# STAFF REPORT

## CONCERNING APPLICATION FOR A CERTIFICATE OF APPROPRIATENESS

**Application Number:** 2019-0211A

**Property Location:** 510 S St Joseph

510 St. Joseph, from the street.

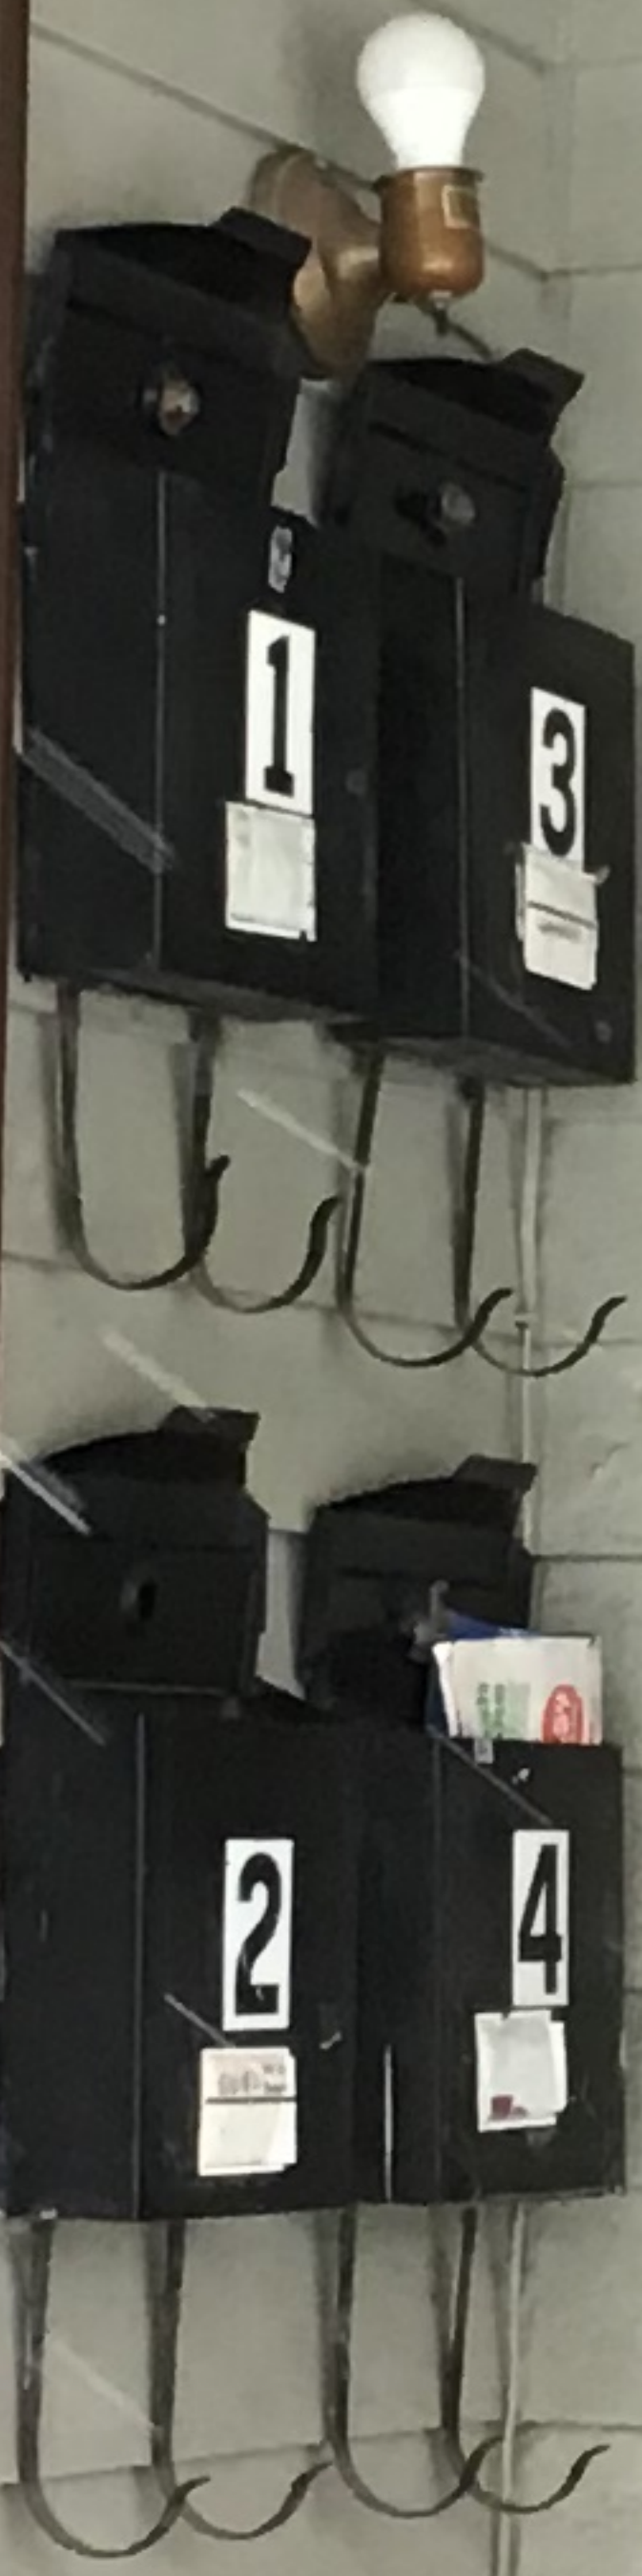
Regarding the retroactive replacement of the front doors, staff would have preferred the original door and storm door would have been retained. The fiberglass replacement door is a departure from the original material and format; Staff would like to see new wooden storm doors installed to conceal the new fiberglass doors.

Regarding the removal and replacement of the four ground floor windows with new vinyl windows, staff recommends approval with the condition that wooden trim be added to conceal the new product. This position is based upon Inspector Szaday’s opinion of the previous windows condition (as documented in COA #2018-0911A).

510 St Joseph Street. South Bend, IN. 46601; the windows will be trimmed in poplar wood using existing color match of trim on other windows. They will mimic the older storm window frames of the property. They will be primed and painted with two coats of paint. All windows are located on the side of the house that faces north.

Also at 510 the front door was replaced, the door is set right but the trim work around and above it is not proper. Above the door I will tear out the scab and install a transit, the transit I am using came out of the house it will be painted and installed. Also the trim boards will be replaced if needed to ensure the period appearance.
